## Response of American Electric Power to Draft Dam Assessment Report Recommendations Philip Sporn Plant

At the request of the U.S. EPA, American Electric Power has reviewed the recommendation section of the draft Dam Assessment Report prepared by Dewberry for the fly ash and bottom ash ponds at the Philip Sporn Plant. In summary, AEP is in general agreement with some of the recommendations, but strongly disagrees with the conclusion that the facilities are "rated as poor" for continued safe and reliable operation. American Electric Power believes a "Fair" or better rating is warranted based on the following:

**ATTACHMENT A**  
**STUDIES IN RESPONSE TO COMMENTS REGARDING POTENTIAL FOR LIQUEFACTION OF EMBANKMENT**  
**AND FOUNDATION SOILS**  
**U.S. EPA DIRECTED DAM SAFETY ASSESSMENT**  
**PHILIP SPORN PLANT – MASON COUNTY, WEST VIRGINIA**

**ATTACHMENT B**  
**PROPOSED ACTION PLAN IN RESPONSE TO DOWNSTREAM EMBANKMENT**  
**SLOUGHING, EROSION AND SURFACE IRREGULARITIES RECOMMENDATIONS**  
**U.S. EPA DIRECTED DAM SAFETY ASSESSMENT**  
**PHILIP SPORN PLANT – MASON COUNTY, WEST VIRGINIA**

Figure 3.5 Comparison of Design Earthquake Loading and Cyclic Strength Curves

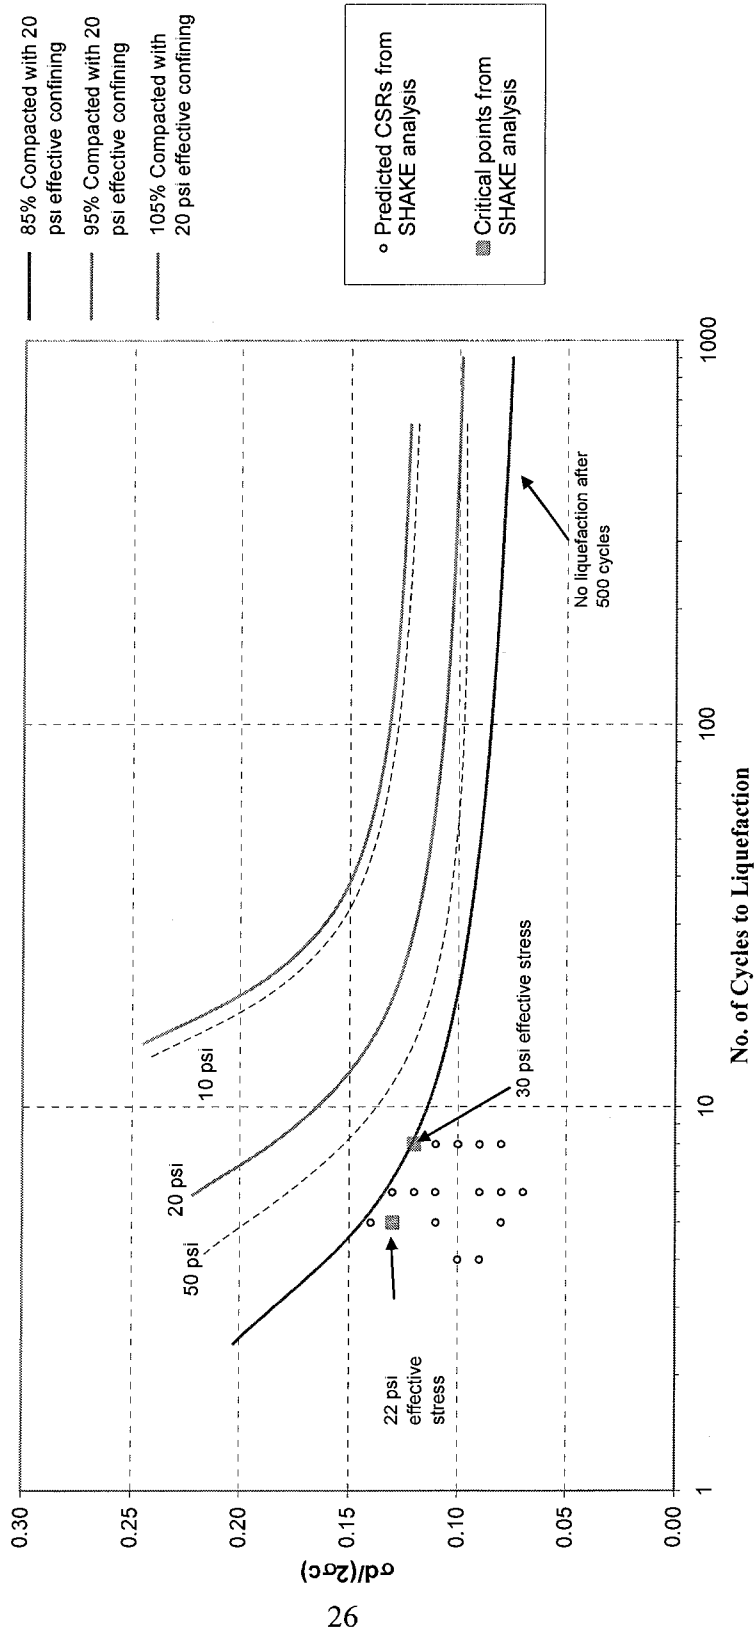
The predicted CSRs and the corresponding equivalent number of cycles (See Table 3.4) are plotted as open black circles in Figure 3.5. As can be seen, all the calculated earthquake loadings were below the cyclic strength curve of samples with 95% relative density which is the typical relative density in the field based on the subsurface investigation information. In other words, the cyclic loading caused by the design earthquakes was lower than the cyclic strength of the fly ash material. The factor of safety depends on the density, CSR and initial confining pressure.

Figure 2. Analysis Results for Existing Conditions

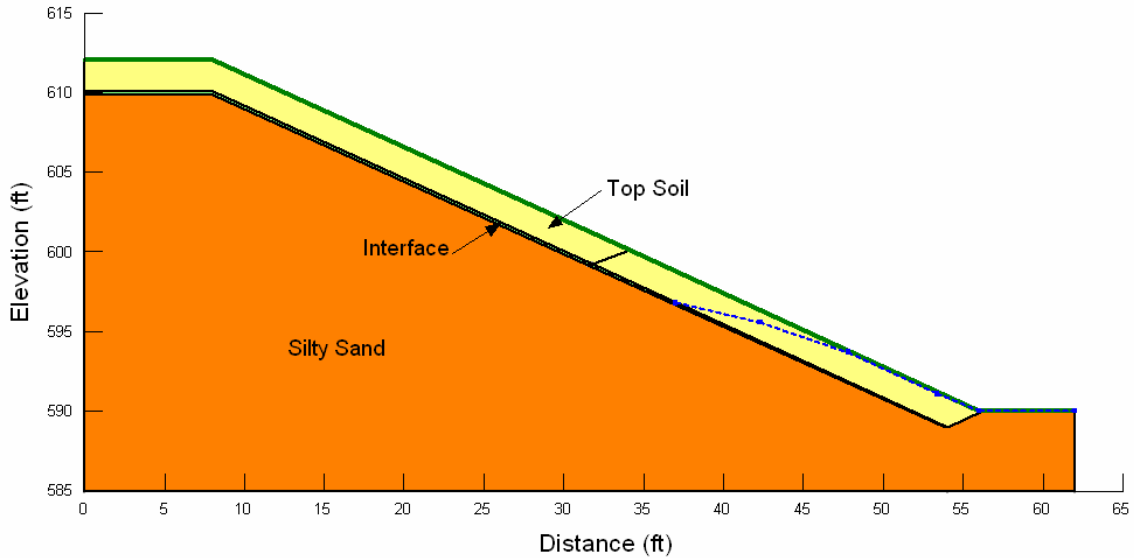
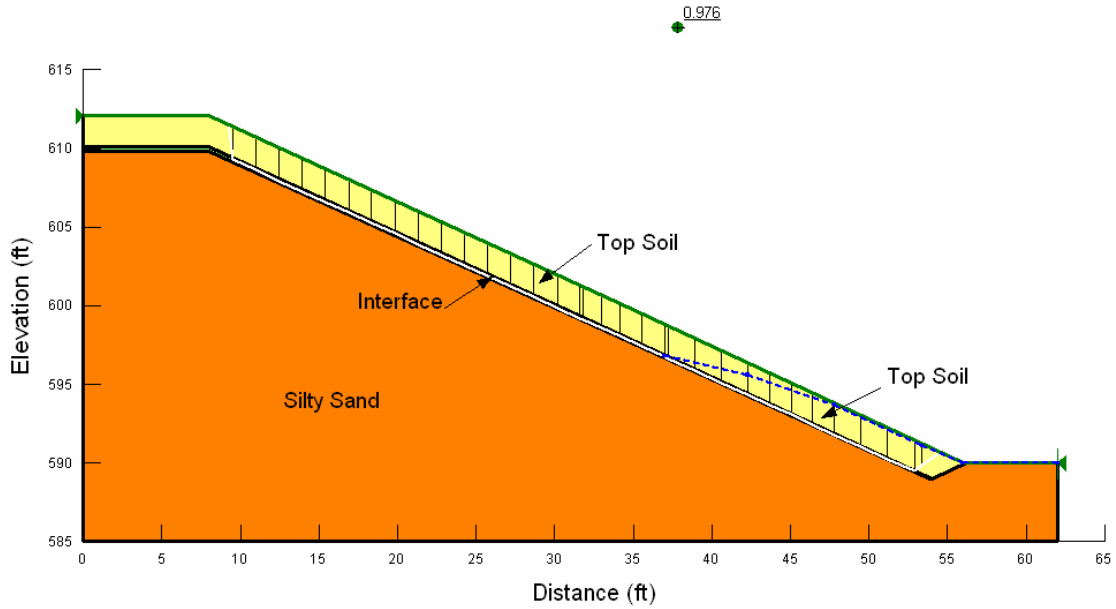
Field observation indicates that topsoil slipping along the topsoil/silty sand interface is occurring as a result of train induced vibrations. These conditions are simulated in a model prepared using Geo/Slope program. Material properties used in the analysis are presented in Table 1.

The analysis showed that factor of safety of less than 1 was reached for slipping along the topsoil/silty sand interface under an equivalent acceleration load of approximately 0.12 g induced by the trains. Figure 2 show the results of the analysis.

Figure 4. Analysis Results for Stabilized Conditions

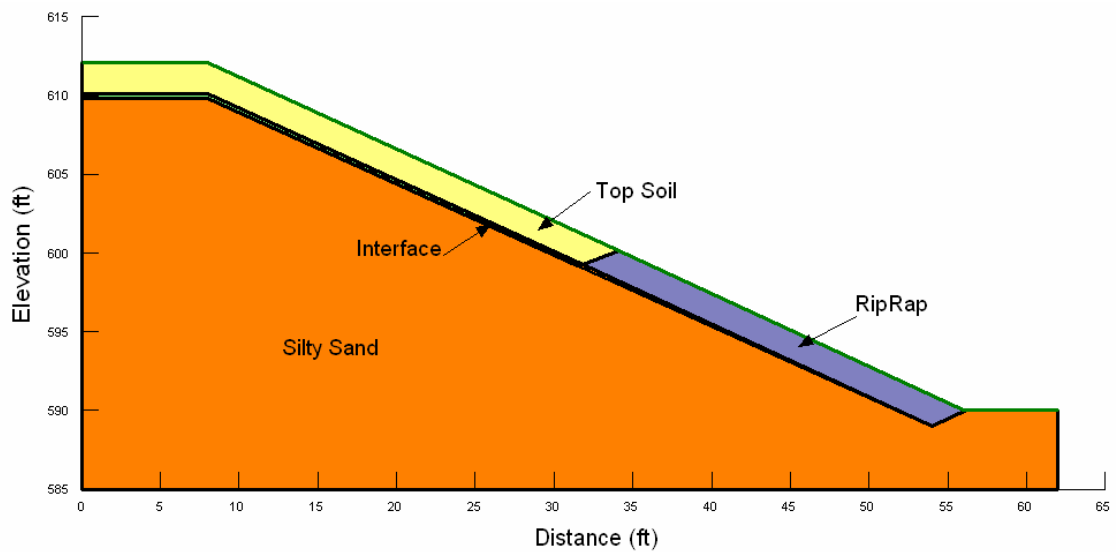
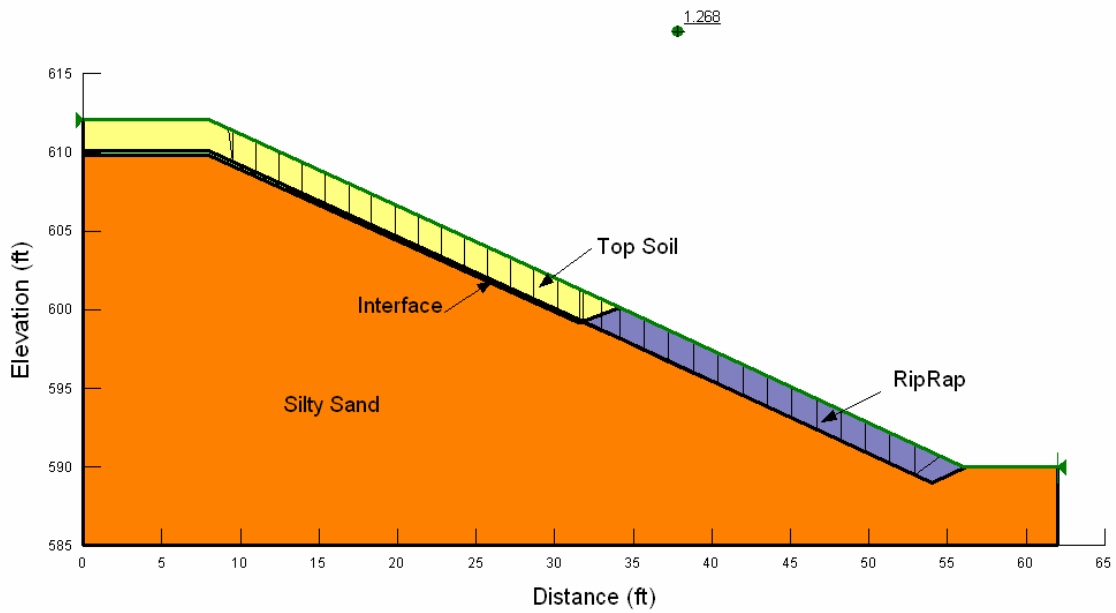
Stabilized scheme include replacing the topsoil at the lower portion of the slope with riprap. The model for the stabilized section is presented in Figure 3. The material property of the riprap is presented in Table 1.

The results of the analysis of the typical section utilizing the proposed stabilization scheme are shown in Figure 4.

Analysis of the stabilized section produced stable conditions with a factor of safety of 1.268 under an acceleration load of approximately 0.12 g induced by the trains. Factors of safety of this magnitude are commonly acceptable for seismic loading.

Figure 7. Results of finite element seepage analysis for Sporn Fly Ash Facility Section K-K predicting controlled internal drainage beneath dikes (Note: Imaginary piezometer predicts a water level that is 7 feet below ground surface)

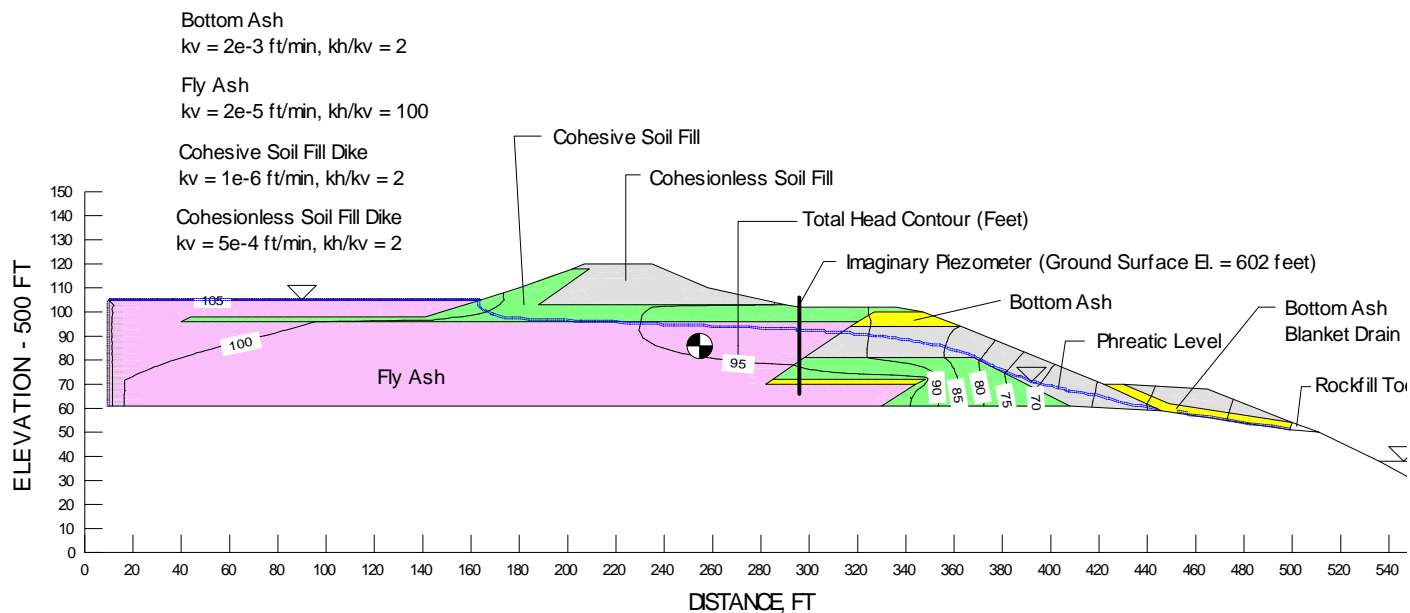
To assess the potential similarities to Kingston with regard to high pore water seepage pressures, finite element seepage analysis was performed for the Sporn Section K-K using a high ratio of horizontal to vertical hydraulic conductivity as recommended by Professor Casagrande. The seepage analysis uses what I consider to be a very conservative ratio of 100 for hydraulically-placed fly ash. As shown by the results in Figure 7, the predicted phreatic level is well below ground surface and is collected by a bottom ash blanket drain and rockfill toe. For the imaginary piezometer shown in Figure 7, the predicted pore water seepage pressure is at a level that is 7 feet below ground surface.

I recommend that a piezometer be installed at the location shown on Figure 7 at Section K-K of the Sporn Unit 5 Fly Ash Facility to supplement the existing monitoring and surveillance program at the site.
